I object to the Beaches Link as presented in the EIS due to the following:

BL EIS Appendix F, Annexure B (Figure 1) shows that just 25% of BL traffic is expected to use the western link through Artarmon. The Warringah Freeway-Gore Hill Freeway has the capacity for this traffic.

Figure 13 – 2<sup>nd</sup> illustration – Beaches Link southbound exit to Harbour Bridge and North Sydney bifurcated to provide direct link to Harbour Tunnel ramps

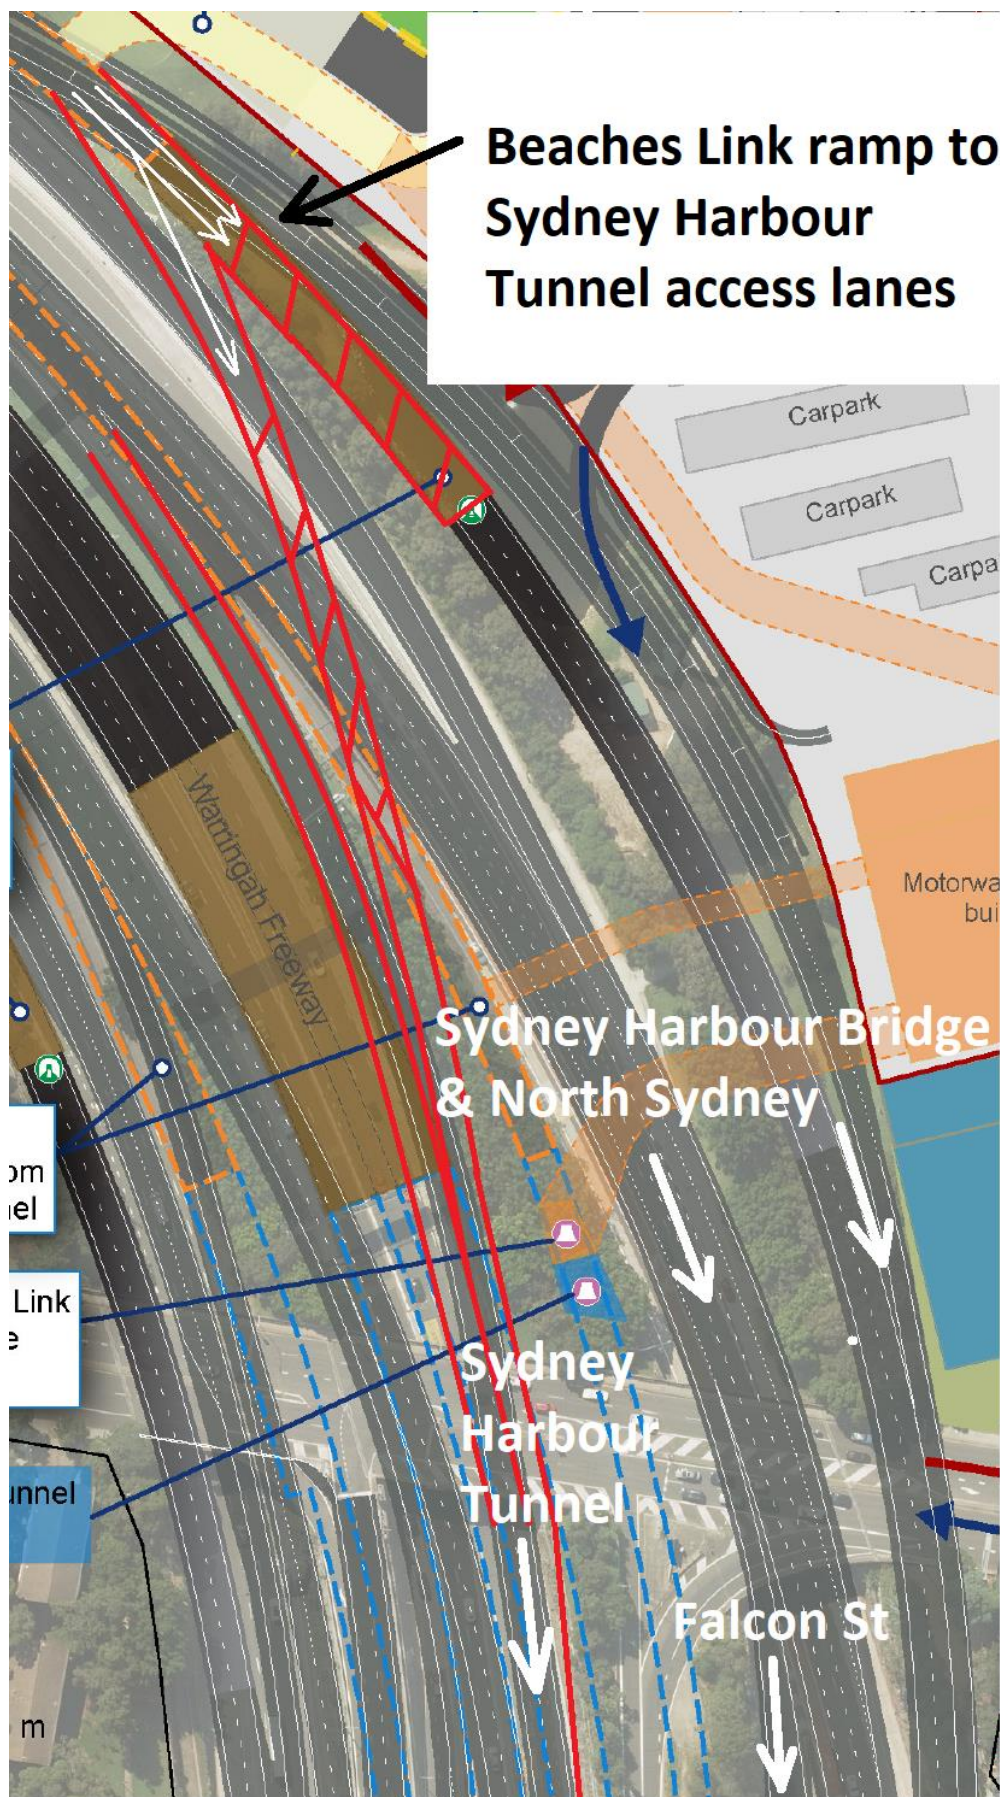
- Beaches Link to and from the Sydney Harbour Tunnel (however, a northbound connection may now be included with RMS's latest go at median strip placement). The Sydney Harbour Bridge must be used and traffic has to mix with Sydney CBD traffic;
- Beaches Link to and from the Pacific Hwy. Dickson and Reserve Roads must be used.
- Beaches Link to Longueville Rd. Dickson Rd and Pacific Hwy must be used.

**Figure 16 – Pacific Hwy-Gore Hill Freeway junction with two right turn lanes added for Pacific Highway northbound traffic to turn onto the motorway**

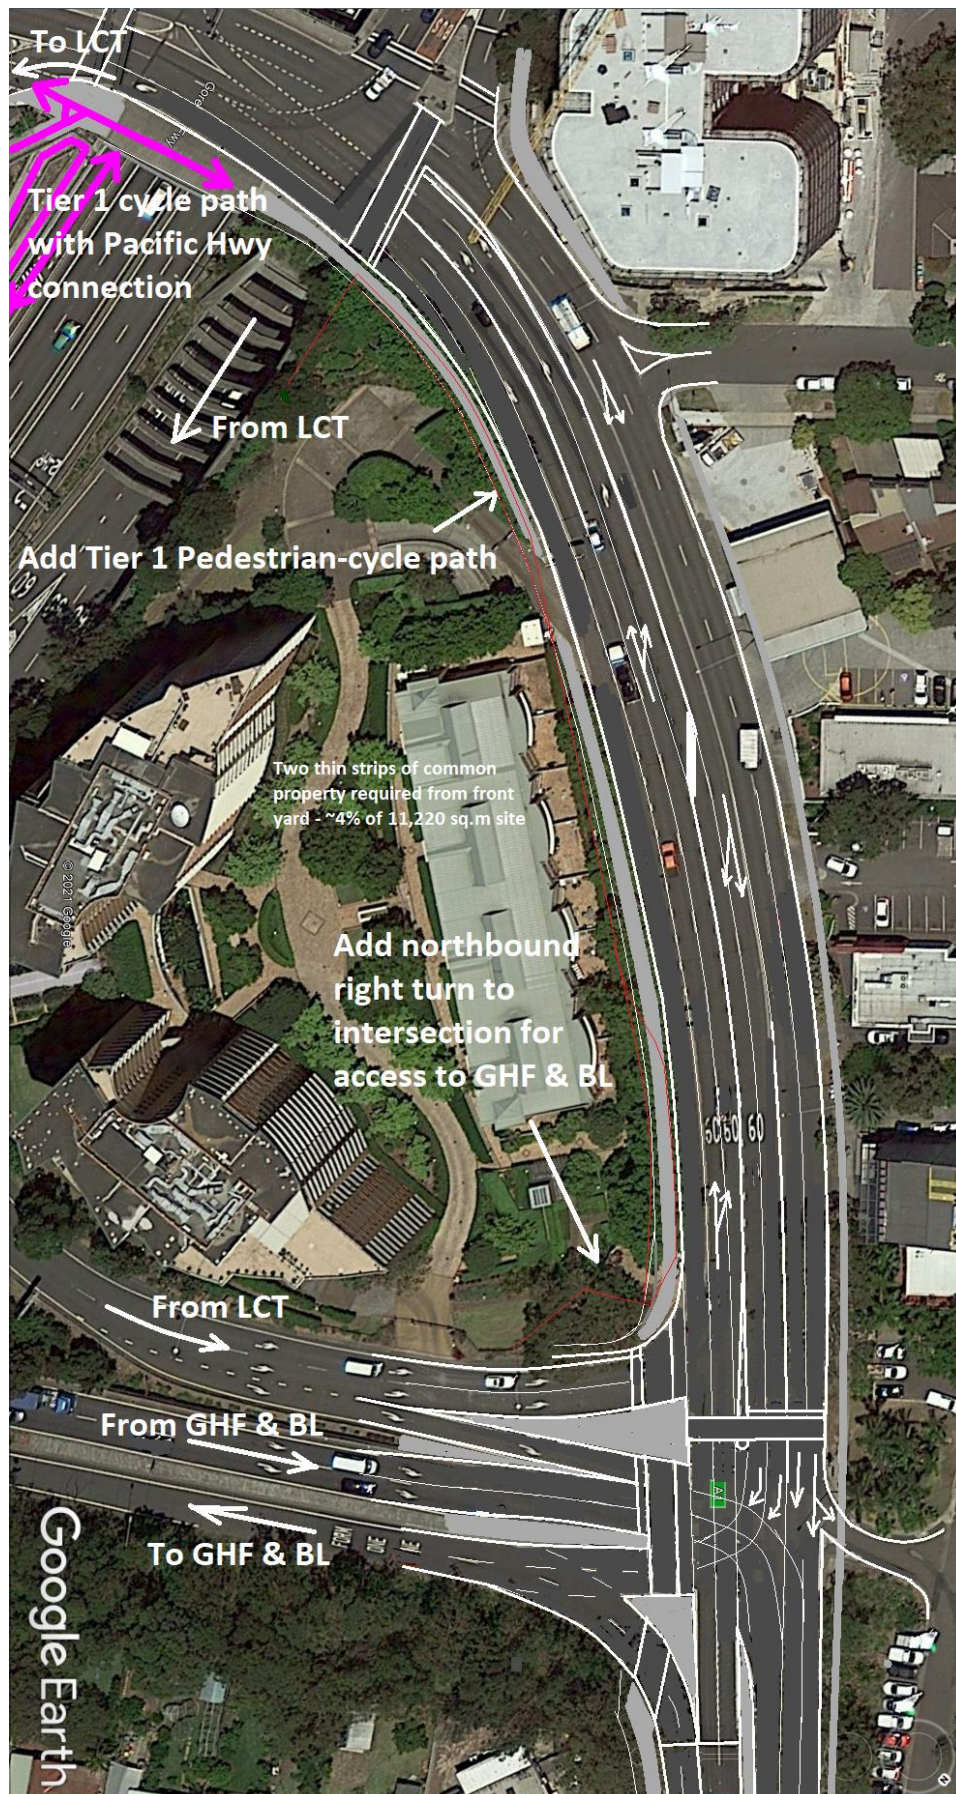
D) Addition of a right turn for northbound traffic on the Pacific Hwy to directly access the Gore Hill Freeway and Beaches Link

Measure D) increases signal phases at the Pacific Hwy-GHF intersection from 2 to 3 phases.

Figure 18 – Additional lanes proposed by Sydney Metro and Willoughby Council for Pacific Hwy Intersection. Proposed is a three-phase signalling. A fourth phase for a Mowbray Rd West right turn lane will fit in the signal cycle time. Compare with Figure 19.

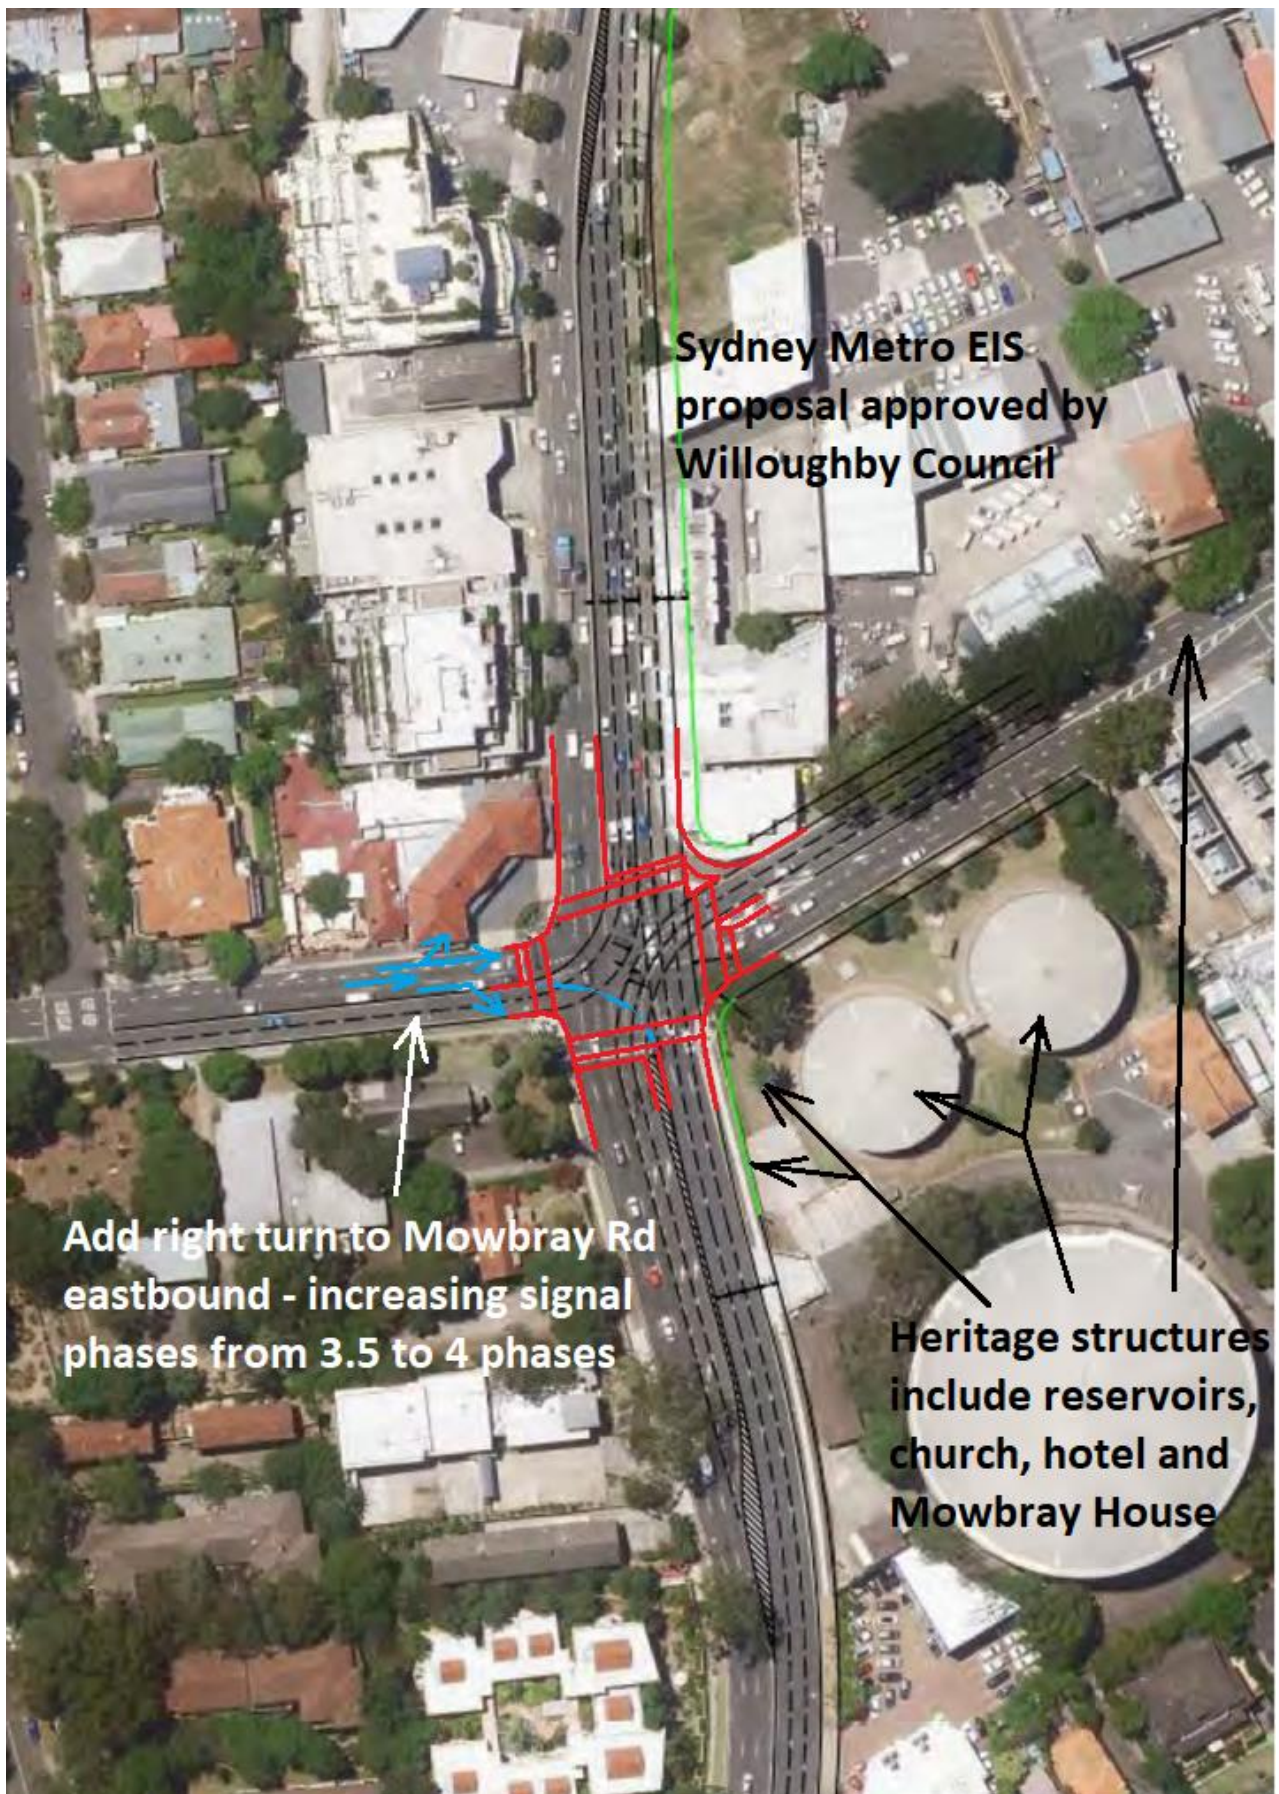
F) Provision of a right turn for southbound Pacific Hwy traffic to access Mowbray Rd West - this has the effect of reducing Pacific Hwy southbound traffic passing through the Pacific Hwy/motorway intersection to turn right at Longueville Rd. This provision was a proposal of

Measure F) increases signal phases at the Pacific Hwy-Mowbray Rd intersection from 2.5 to 3.5 phases.

Measure E) increases signal phases at the same intersection from 3.5 to 4 phases.

Figure 21 – Pacific Hwy/Boundary St intersection – either add the planned extra lane south of Boundary St now, or reduce the southbound through lanes from 3 to 2 north and south of the intersection to provide an extra right turn lane 160 metres long.

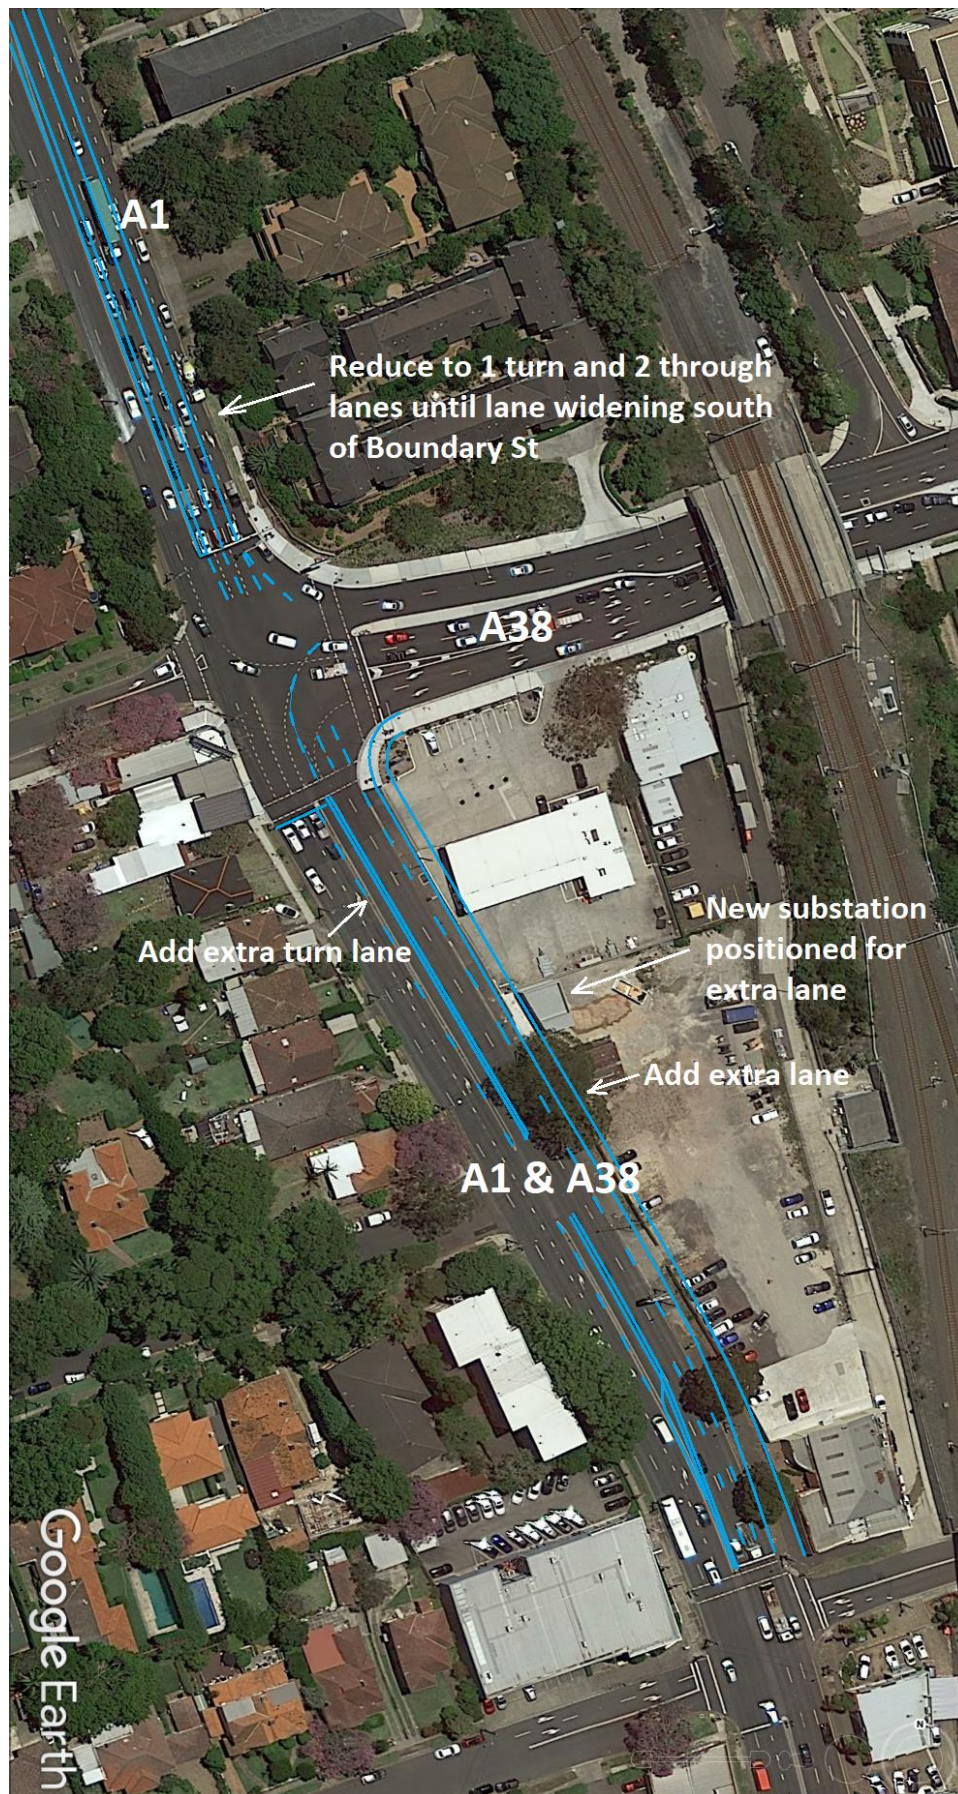
G) Provision of a second right turn lane from the Pacific Hwy at Fullers Rd and Boundary St.

Figure 22 – Due to the lack of team sport playing fields in the Artarmon-Naremburn area, restore Artarmon Park with a deck over the motorway between Hampden Rd and the North Shore Railway Line. There is space available for two football fields while retaining the native forest along Parkes Rd.

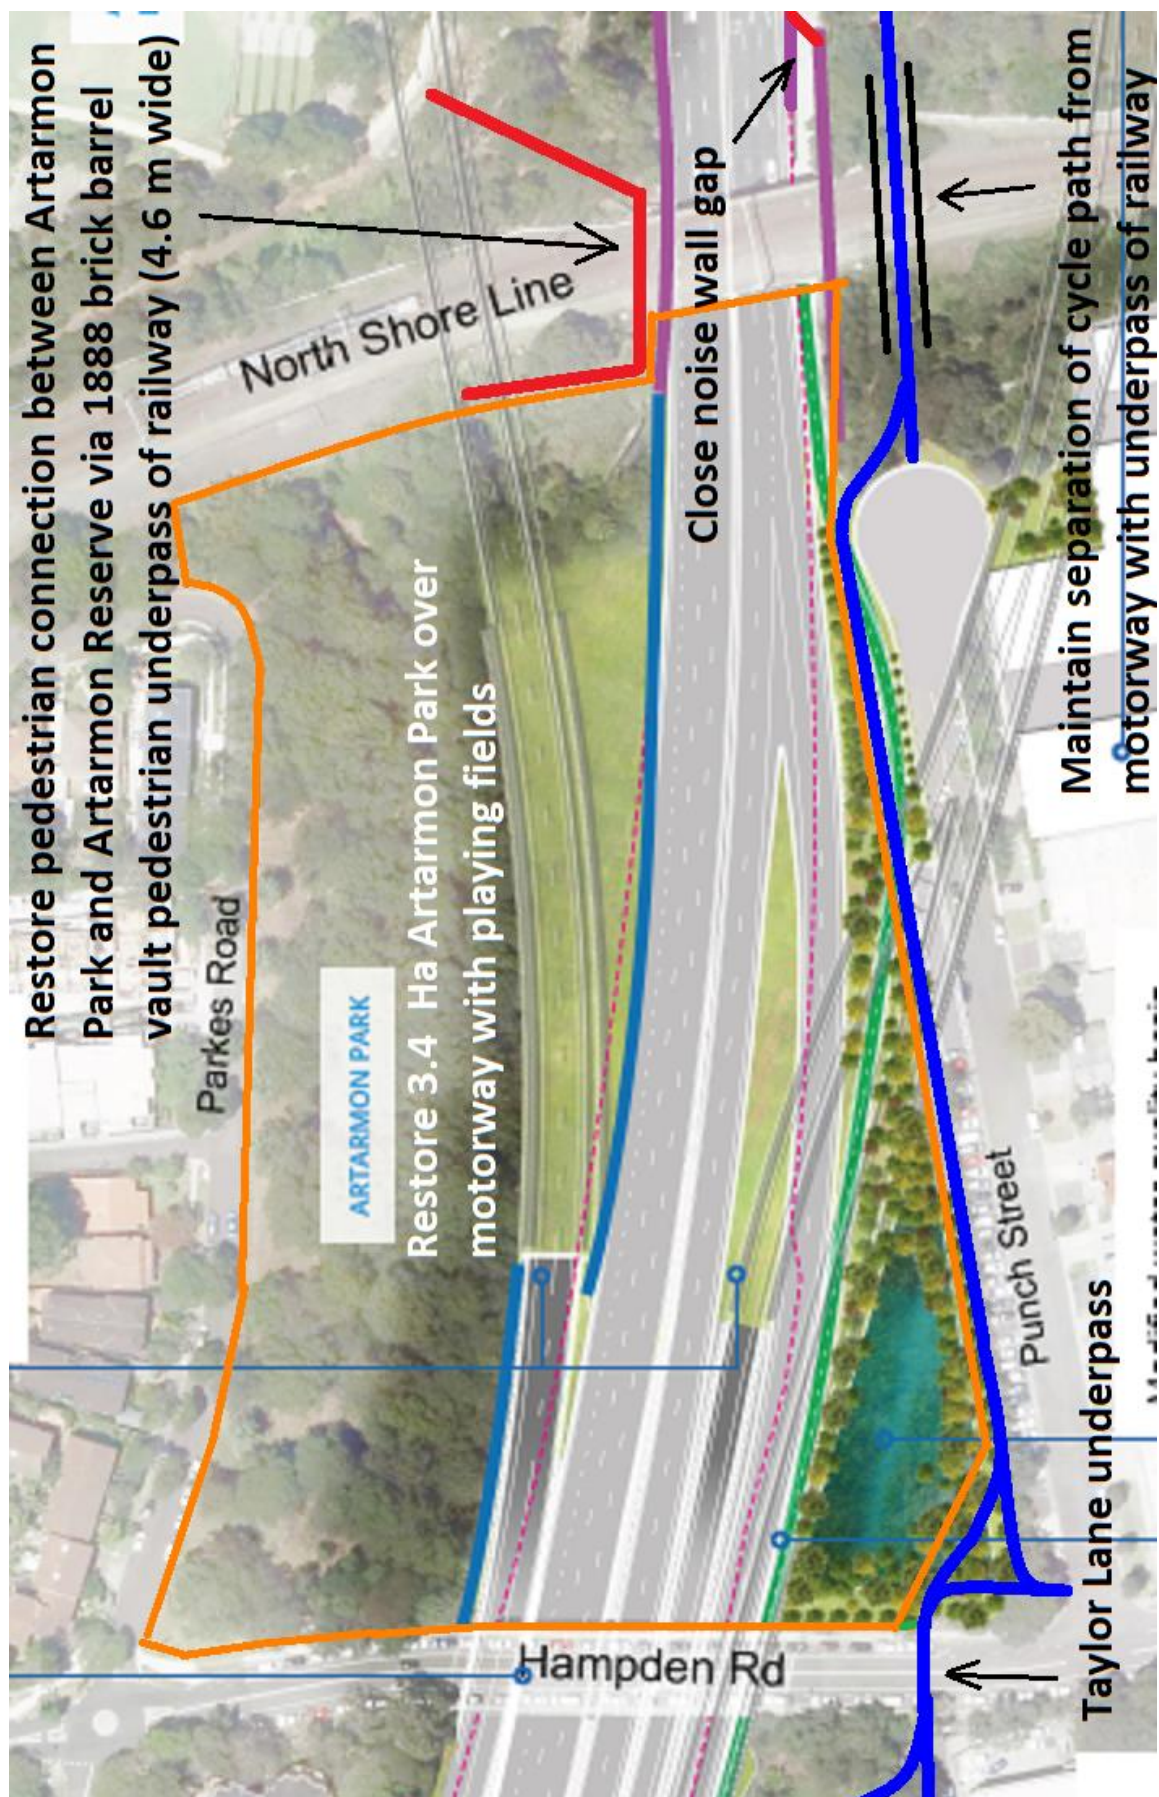
The stopping of organised amateur sport in 2020 to minimise Covid transmission has revealed a high demand to use Thomson Park Artarmon by the local residents. Organised sport should move elsewhere. The restoration of Artarmon Park over the motorway will yield two football fields while retaining the forest along Parkes Rd. See Figures 22 to 24

Figure 25 – Temporary cycle path to Cleg St

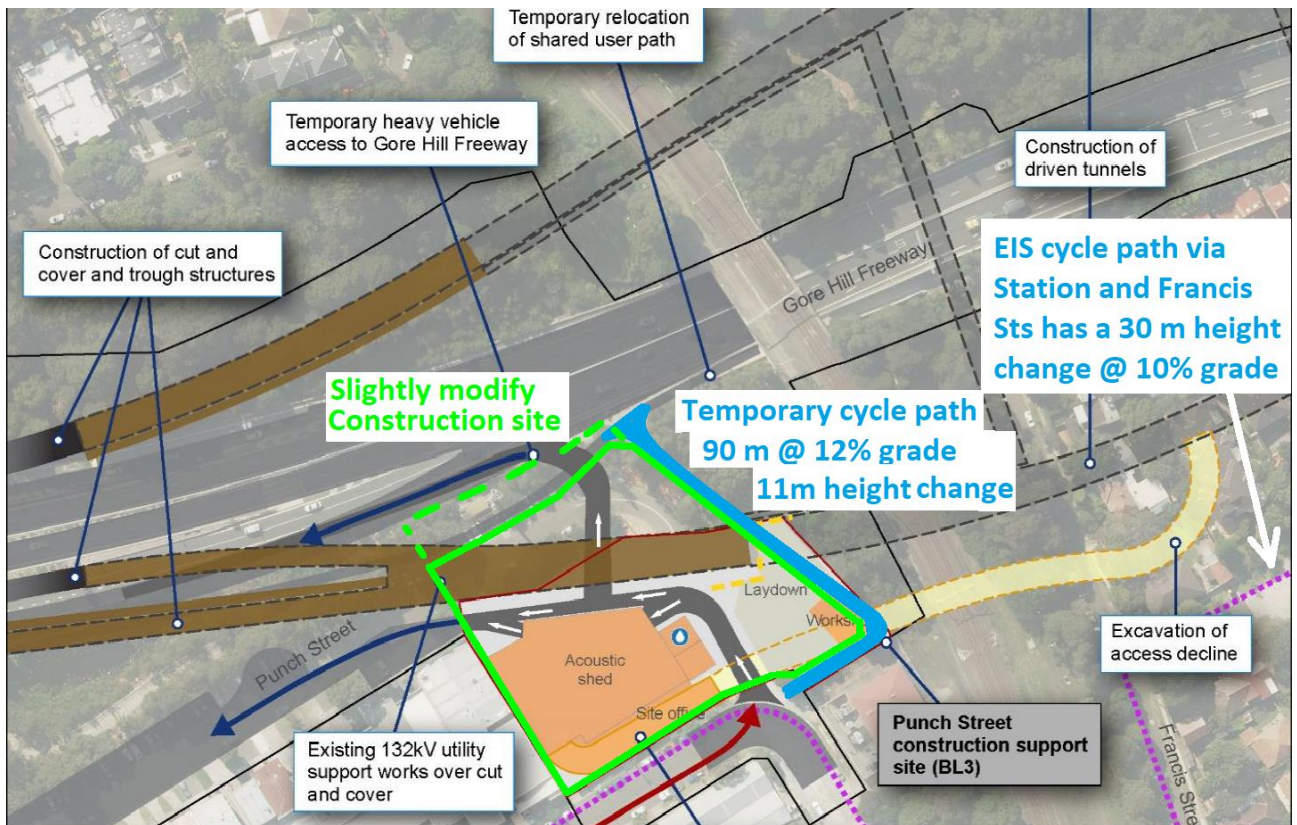
The Station St/Francis St route proposed in the EIS has a 30-metre rise in height from the Flat Rock Creek crossing to the Lambs Rd railway overpass – much of this at a 10% grade. A better location for a temporary cyclepath is along the western side of the railway embankment as illustrated in Figures 25 to 28. This route has an 11 metre height increase at a grade of about 12% over a length of 90 metres.
